**I.1.a.j 701 Tyee Road (Railyards) - Development Permit with  
Variances Application No. 00080 (Victoria West)**

**Subject:** Development Permit with Variances Application No. 00080 for 701 Tyee Road (Railyards)

We have addressed the Advisory Design Panel's comments held on 25 July 2018 regarding the Development Permit (DP) application for 701 Tyee Road (DPV00080). We have addressed all comments and revised the design accordingly. The following is a summary of our response and revisions. *\*\*\*Note: the orientation of the building has been changed to project north rather than on cardinal axis\*\*\**

A1.4

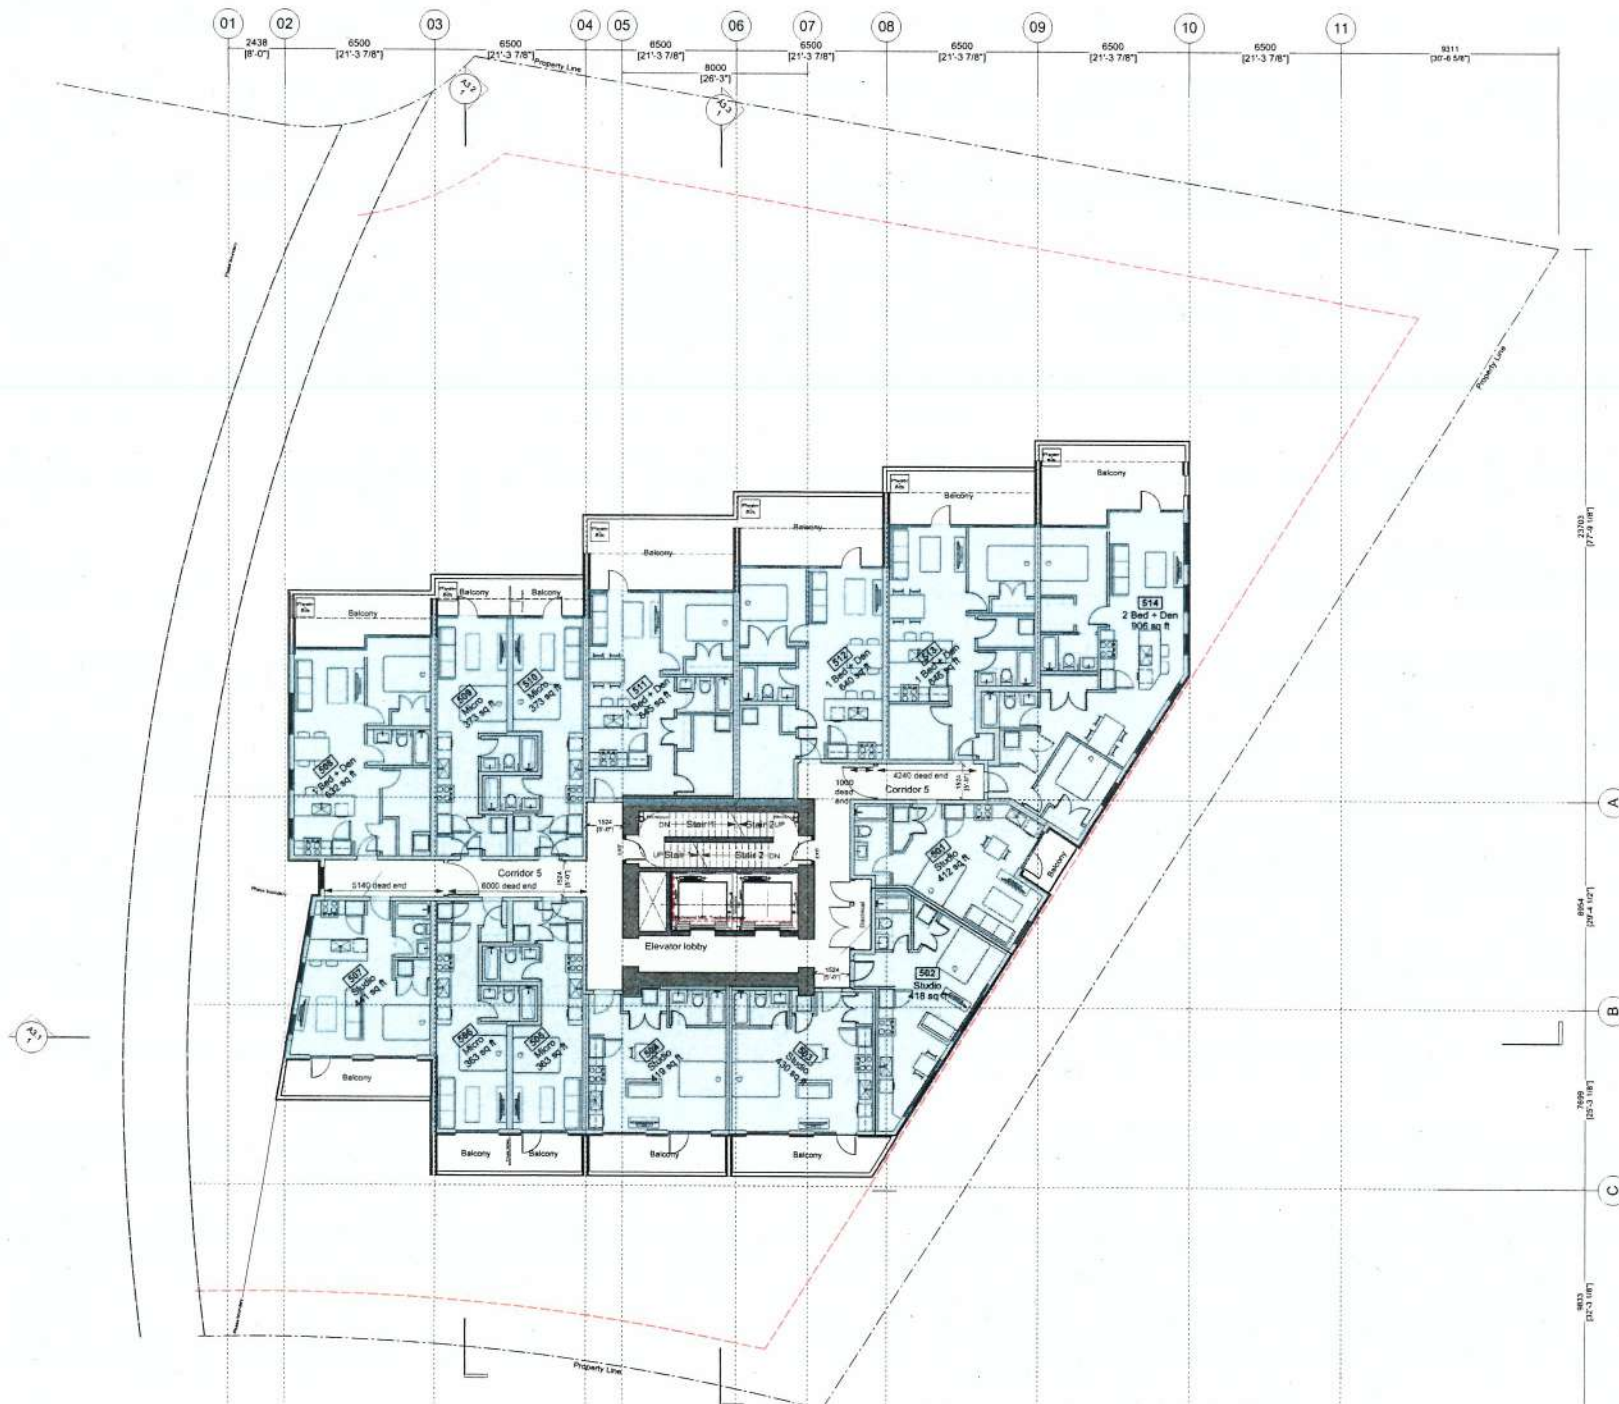
5. ADP comment: *Increase the amount of greenspace on the third floor patios to visually enhance the outlook for residents.*  
Response: We have increased the green roof area from approximately 1,000 sq.ft. to 3,000 sq.ft. or a 300% increase. Refer to drawings A1.4 and Landscape Plan.

1 North Elevation  
Scale: 1:100

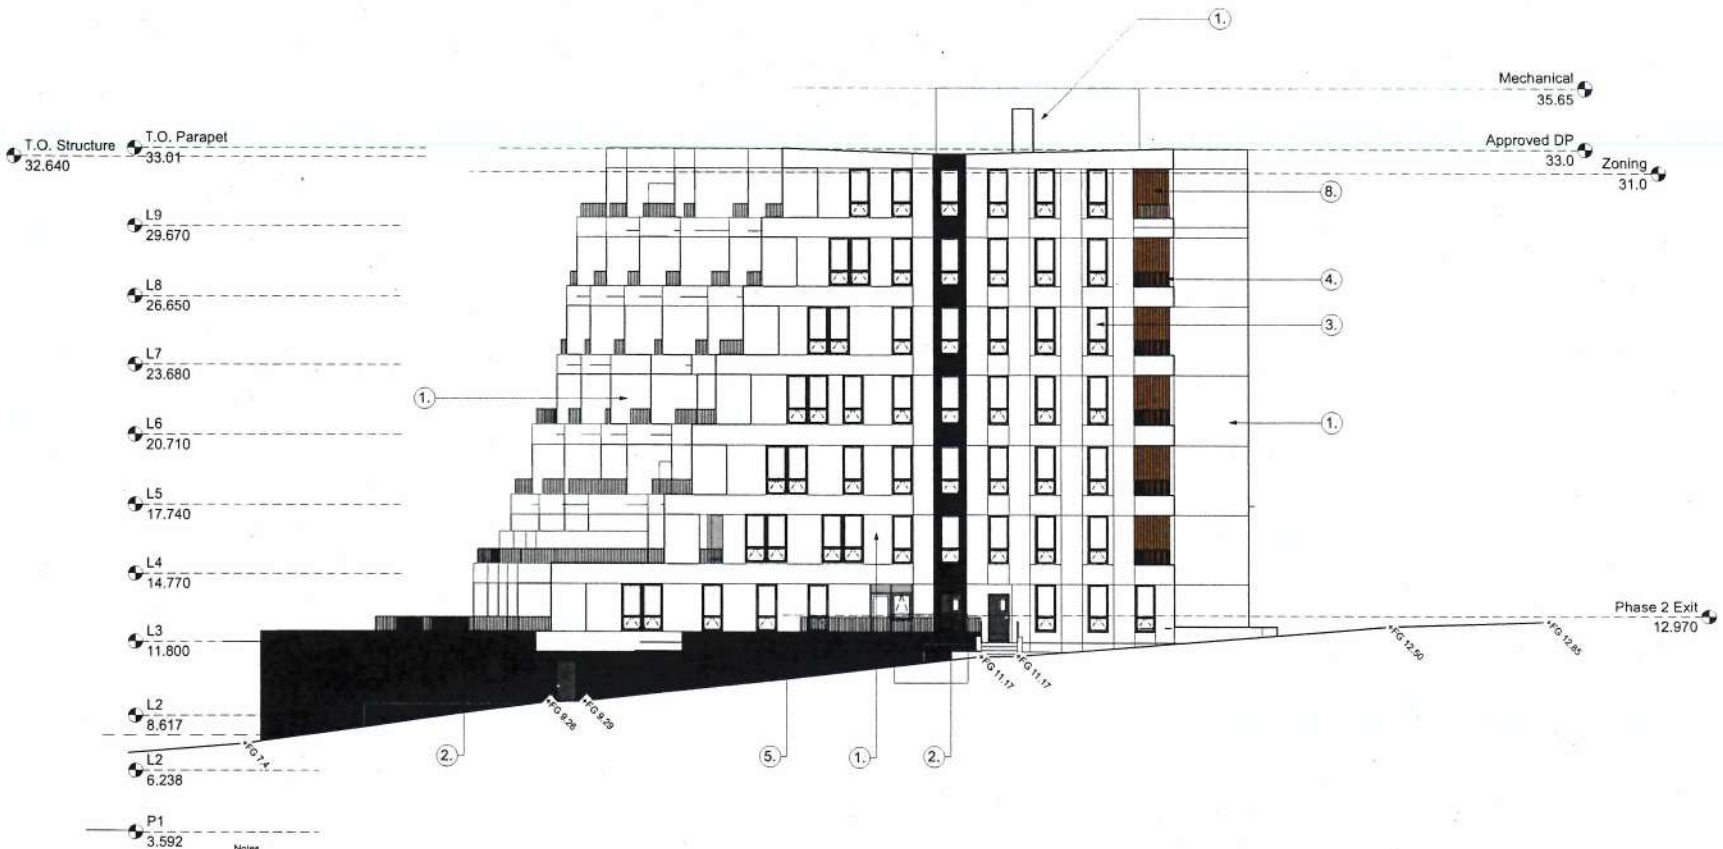
1. ADP comment: *Re-examine the east façade (project north façade) to express the organizational element behind the cascading proportions.*  
 Response: We have aligned the vertical fins on every floor on the north and south façades and carried up the walls so that the cascading proportions are kept within the vertical partitions. In addition, the strategic use of privacy screens as well as planters provides life to the individual balconies. Refer to drawings A2.2, A2.3 and A4.3
